**NUMBER:** 08-054-05

Ambient Temperature Reads Higher Than Actual

This bulletin involves moving the ambient temperature sensor to a new location.

2006 (XK) Commander

**Fig. 1 AMBIENT TEMP SENSOR HARNESS**

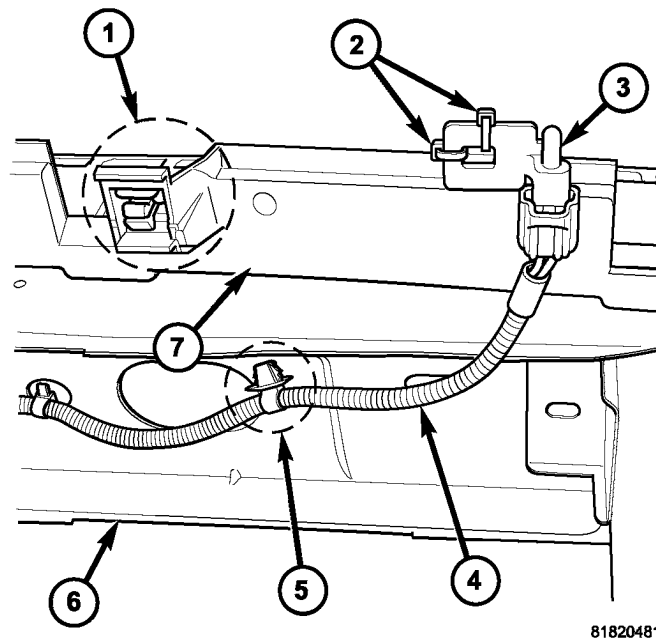
This condition may be caused by the original location of the ambient air temperature sensor. The sensor may be too close to the radiator and other heat exchangers.

4. Detach (unclip) the ambient temperature sensor from the front fascia support. The ambient temperature sensor will be relocated outboard (towards the right side) from its original location by approximately 5 inches.

- 1 - Original (Old) Location Of Ambient Air Temperature Sensor
- 2 - Two Plastic Tie Straps Required To Hold Sensor In Correct Position
- 3 - Ambient Air Temperature Sensor - New Location
- 4 - Ambient Air Temperature Sensor Harness
- 5 - Harness Clip - Detach (Unclip) From Front Crossmember
- 6 - Front Metal Crossmember
- 7 - Front Fascia Support Panel

**Fig. 2 AMBIENT TEMPERATURE SENSOR**

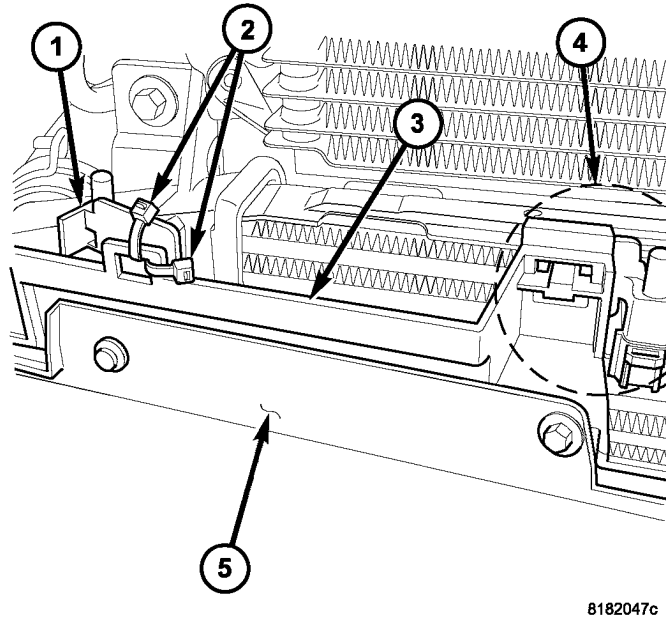
5. Detach the ambient temperature sensor harness plastic retainers (clip) that is closest to the ambient temperature sensor. The retainer attaches the ambient temperature sensor harness to the front bumper cross-member. The retainer must be detached to allow relocation of the ambient temperature sensor (Fig. 2).

6. Secure the ambient temperature sensor to its new location on the front fascia support. Attach the sensor to the fascia support using two plastic tie straps. The plastic tie straps must be located 90° from each other (one strap positioned horizontally, and the other strap positioned vertically). Verify that the tie straps are snug to the sensor and fascia support panel.

- 1 - Ambient Temperature Sensor - New Location
- 2 - Plastic Tie Straps - Two Required. One Strap Horizontal And One Strap Vertical
- 3 - Front Fascia Support Panel
- 4 - Typical - Old Location - Detach (Unclip) Air Sensor From This Location
- 5 - Front Fascia
